TOWN OF YARMOUTH
200 Main Street, Yarmouth, Maine 04096
www.yarmouth.me.us

Planning Board Report
90 Main Street

Second Concept for Development Plan, Building & Lot Plan, Major Site Plan, and Major Subdivision

Report Date: July 14, 2022; Planning Board Date: July 20, 2022

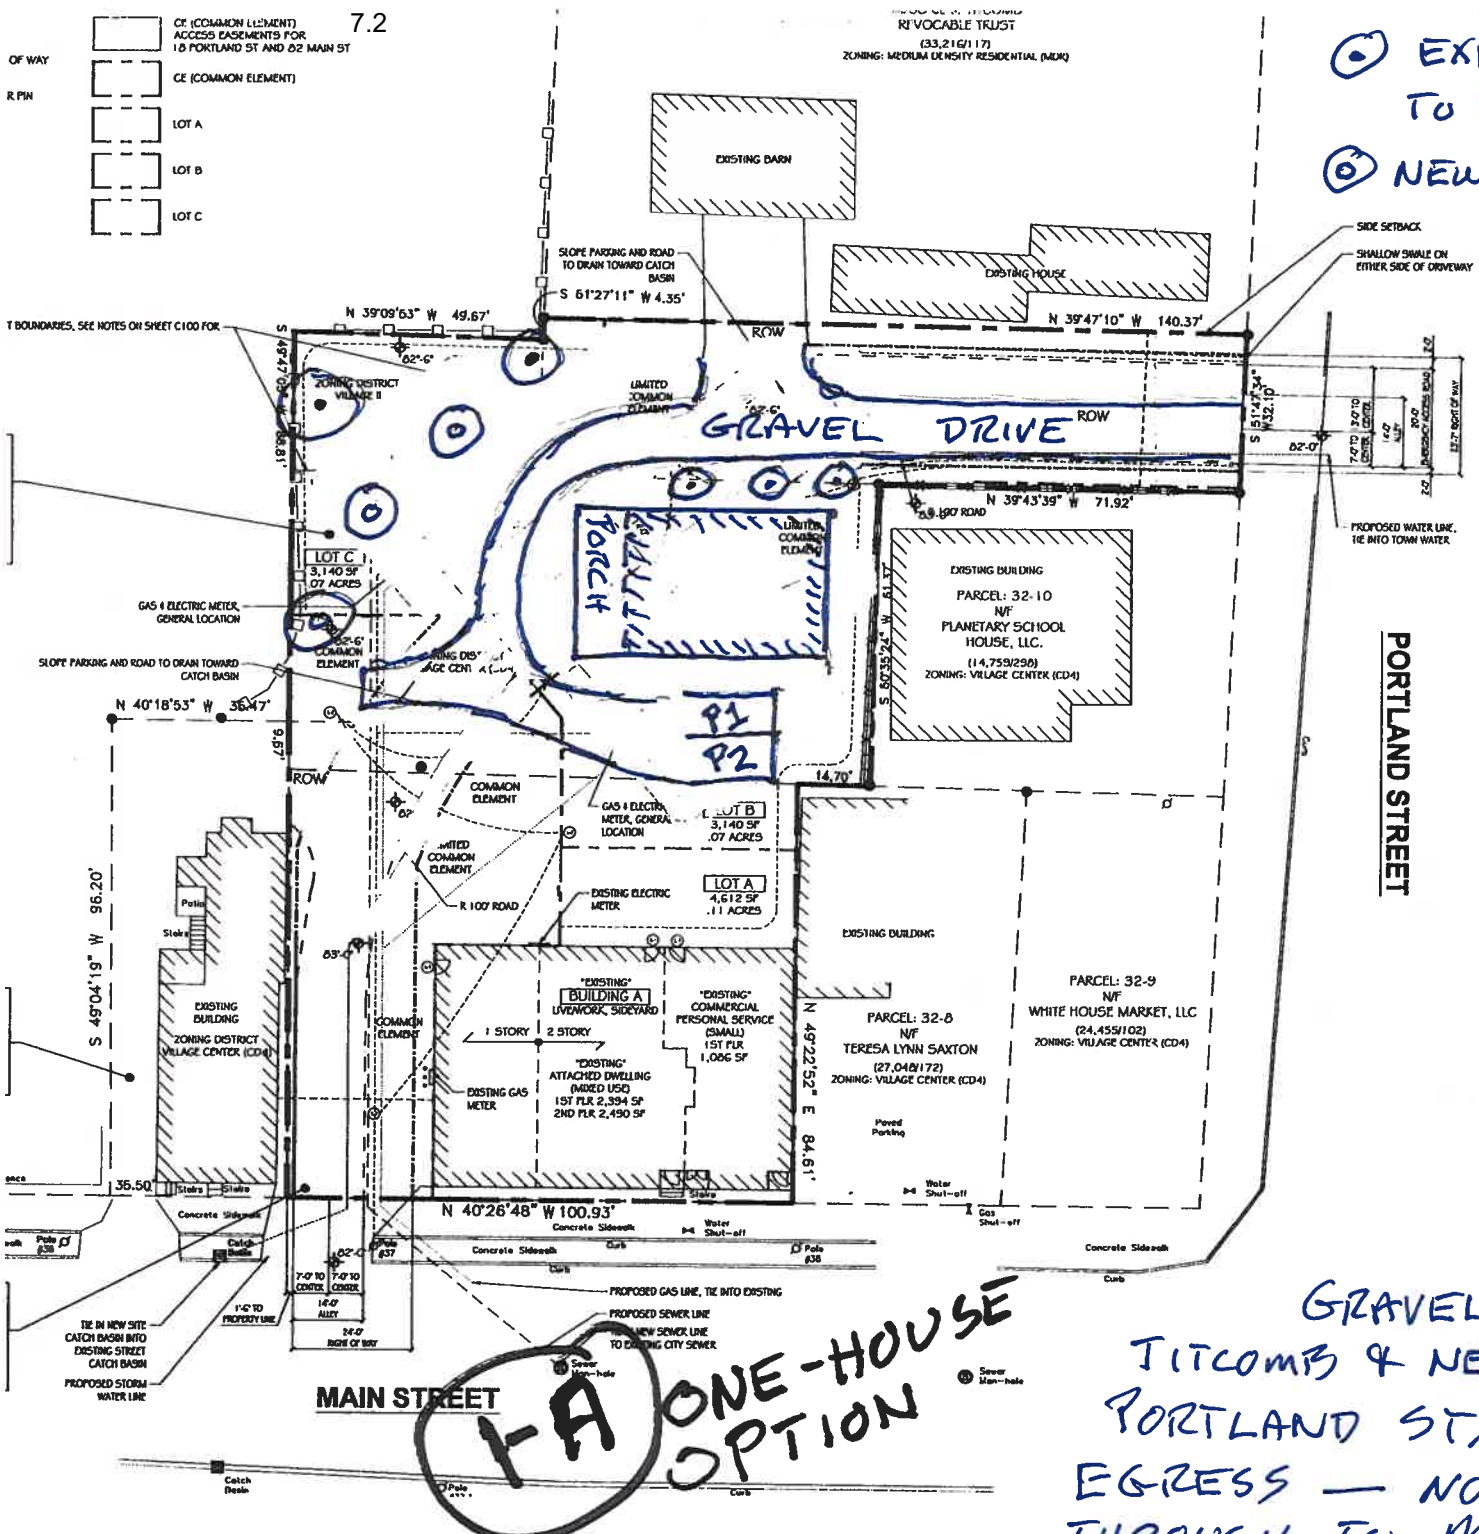
Sketch 1-B is a variant of the one house option, where the bungalow looks down the driveway to Portland Street, and the parking is a straight shot from the driveway. This gives a nod to the CBDC, by fronting on Portland Street, albeit set back a good ways. This has the considerable added benefit of a turnaround shared with the Titcombs, taking advantage of the Titcombs entrance without using up additional space. This would obviously require the consent of the Titcombs, but it could be useful to them as well. This also shortens the overall driveway length, using less space which could then be devoted to landscaping /green space. This sketch shows existing trees to be retained, but I did not add suggested additional landscaping, for which there is great potential. I think this is the best treatment.

For Sketch 2-B, I took a tweak from 1-B, and relocated the parking for each house, making a shorter and simpler driveway, and doing away with the hammerhead turnaround shown on 2-A. That would mean losing a couple more of the existing maple trees lining the driveway at present. Balancing the competing factors of development and retention (or replacement) of extensive tree canopy presents a real challenge here, and some creative landscaping would be called for.

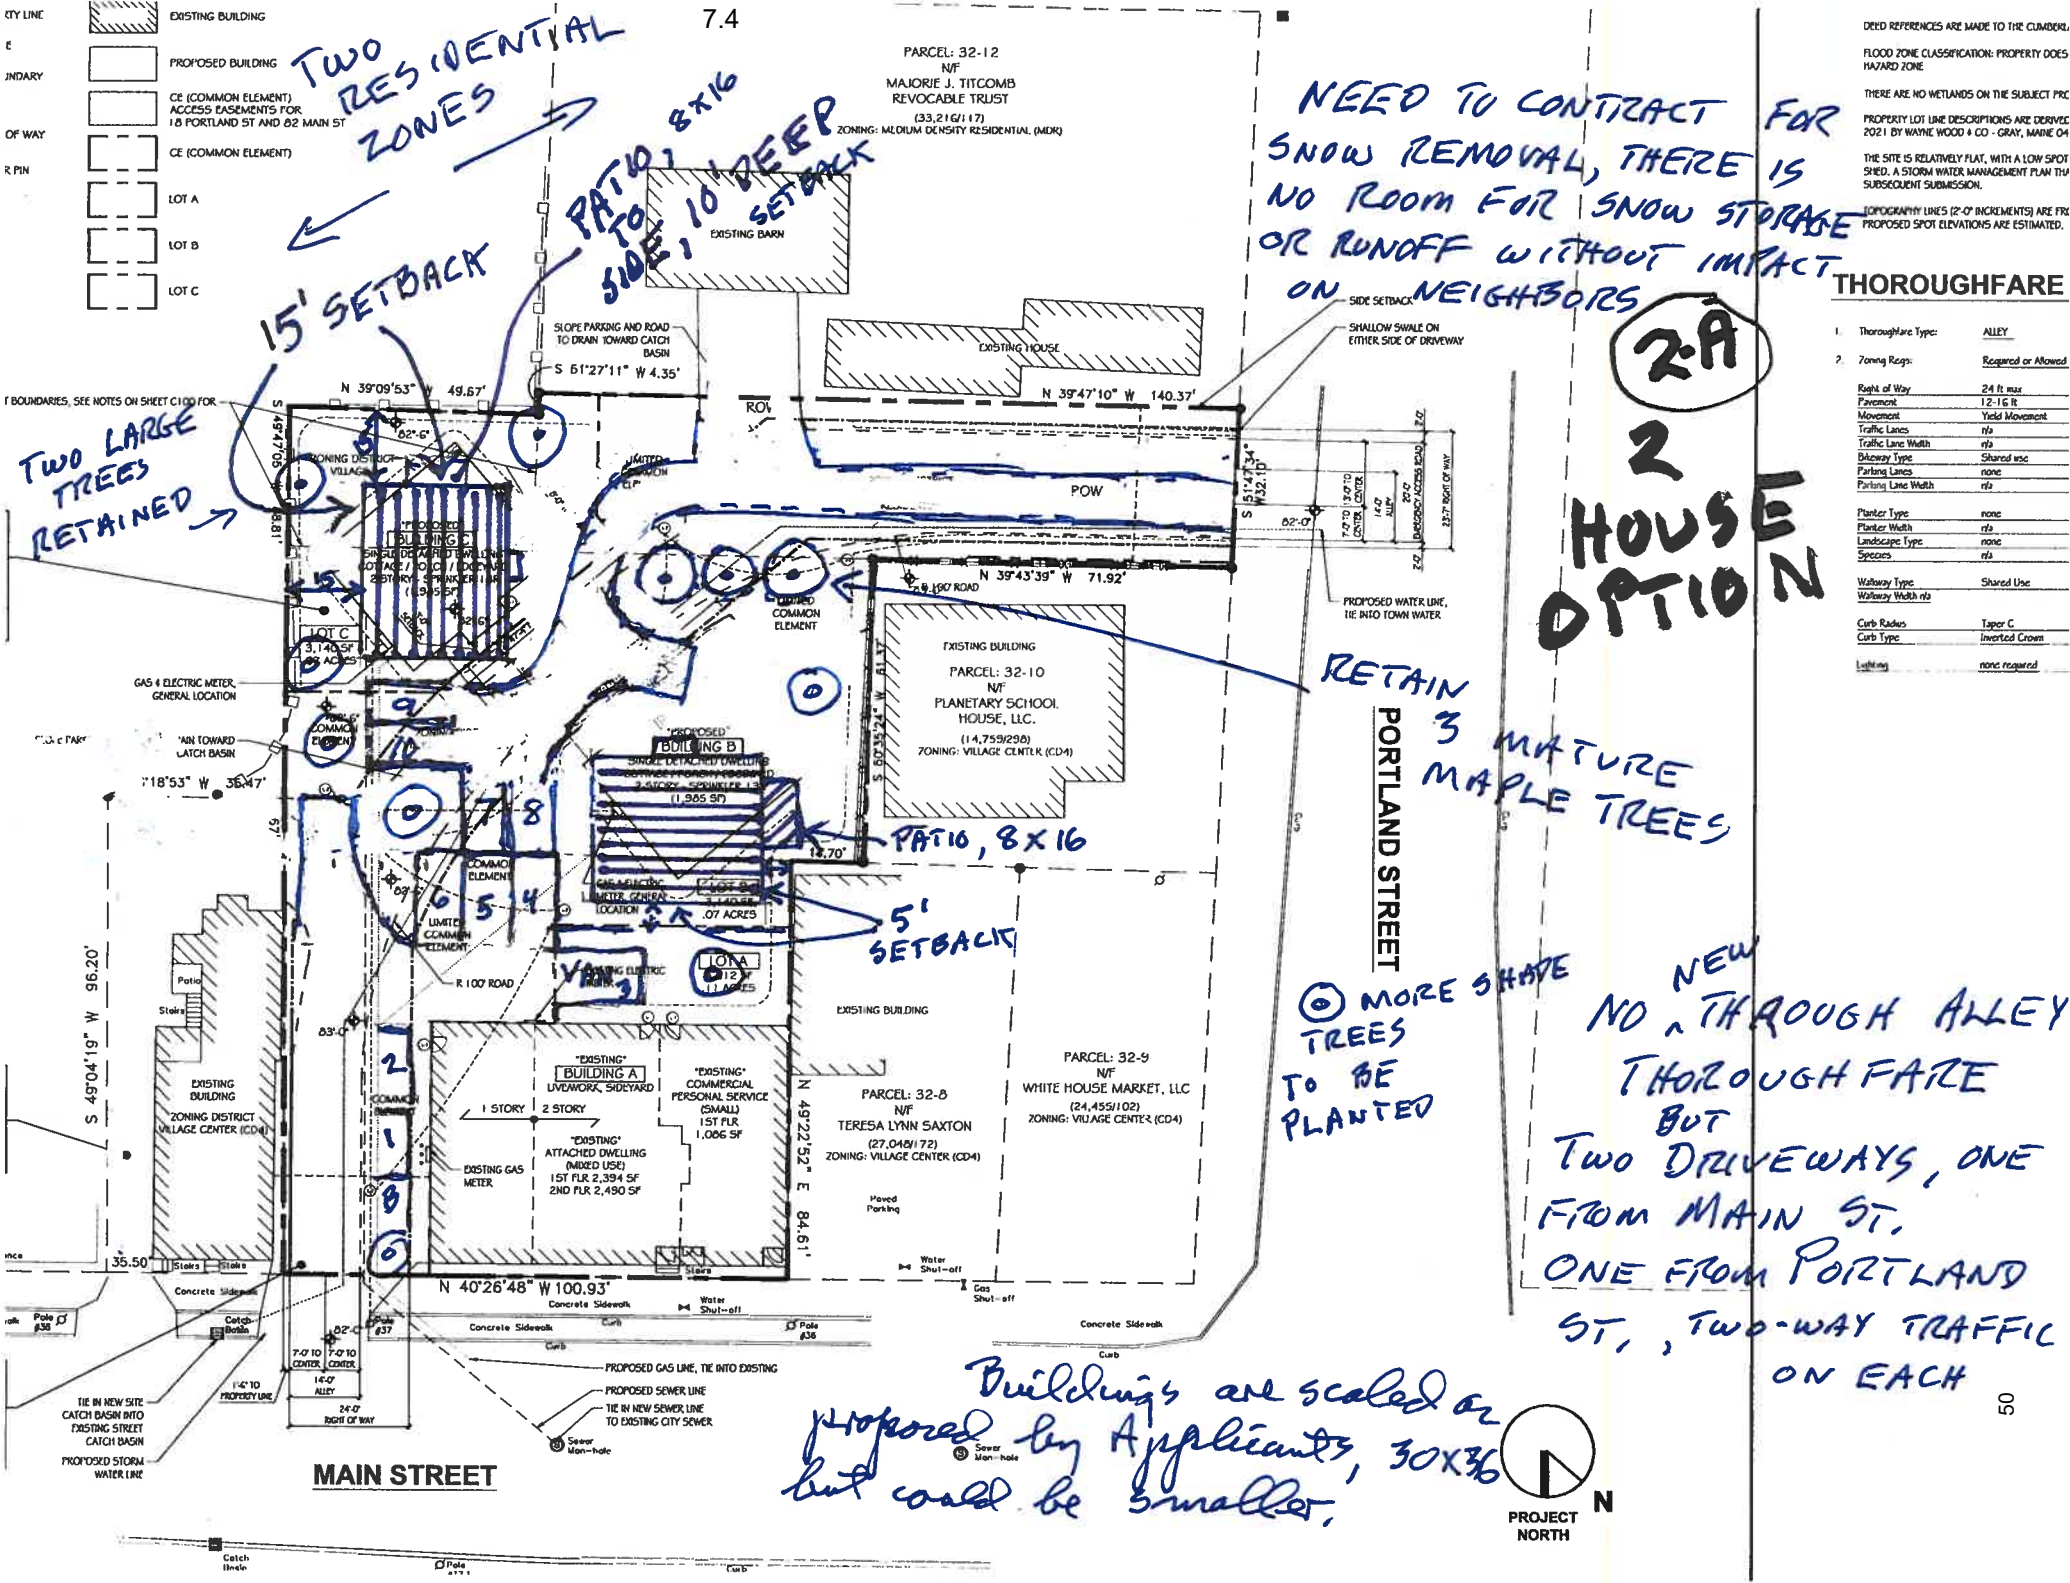
TWO LARGE TREES RETAINED
